**RE: PART VIII - Urban Enhancement & Improvement - Ormonde Street,
Kilkenny**

Chief Executive's Report on the Public Consultation Process
for Ormonde Street Urban Enhancement and Improvement Works.

Ormonde Street, Kilkenny Urban Enhancement and Improvement Works.

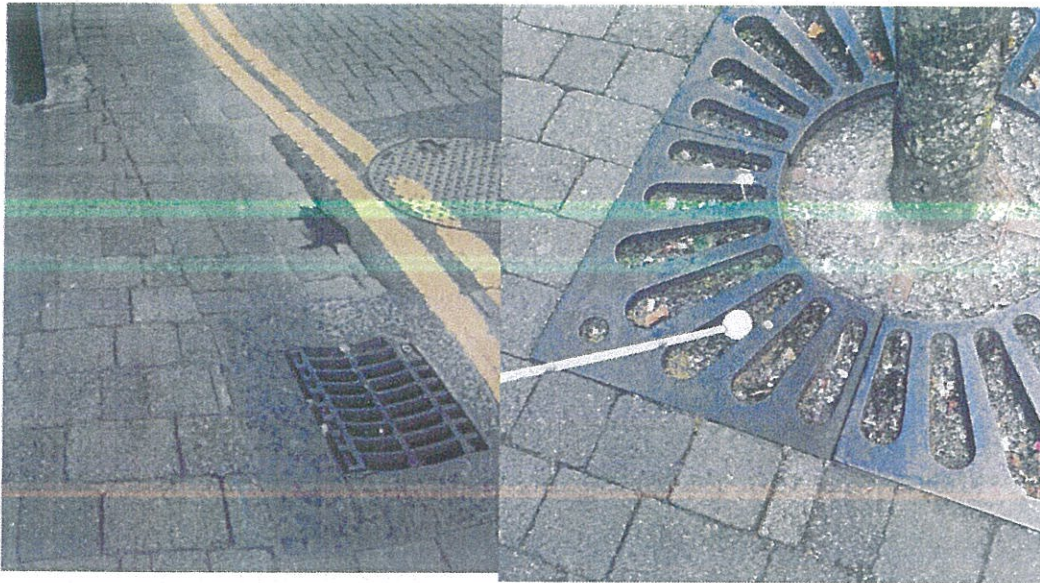
Below are photographs showing how street furniture which is not aligned forms an obstacle course for anyone with impaired vision.

It also makes Ormond Street quite challenging for a wheelchair- user, or for parents trying to take care of young children, while also wheeling a pram or buggy.

When a footpath with a kerb-edge is installed on Ormond St., there should not be any need for bollards, as a kerb of a good height will deter motorists from parking on the footpath. Will the bollards therefore be removed?

(d) Trees, hanging baskets, plant pots.

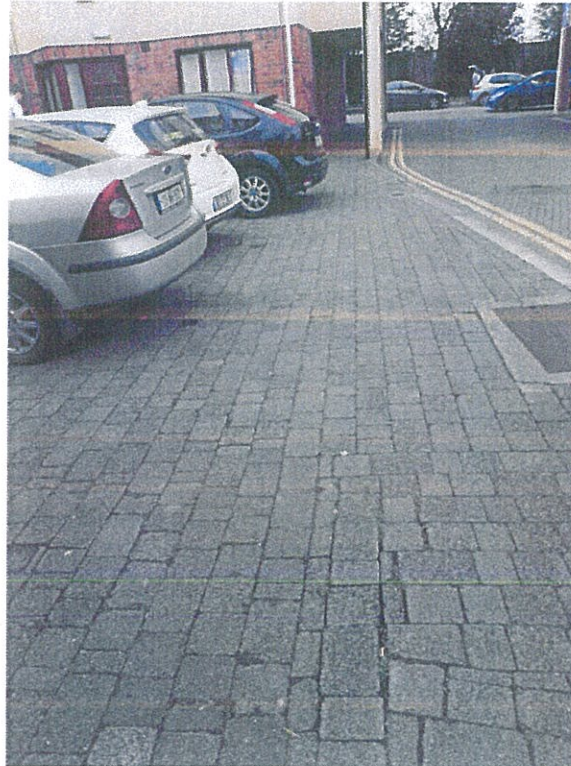
Kilkenny is a beautiful and well-kept town, and the trees and flowers make the town very attractive and pleasant for everyone. NCBI recommends ensuring that hanging baskets are always hung high enough so that even tall people with impaired vision do not find their heads bumping into them, and that low tree branches are trimmed back.

Below left is an example of a tree which needs “underskirting” as it is called. This is near the New Street end of Ormond Street. Below right is an example of good practice – plant pots which are rounded, do not block the footpath, and contain plants which do not protrude into the footpath area at face height. They look lovely, too!
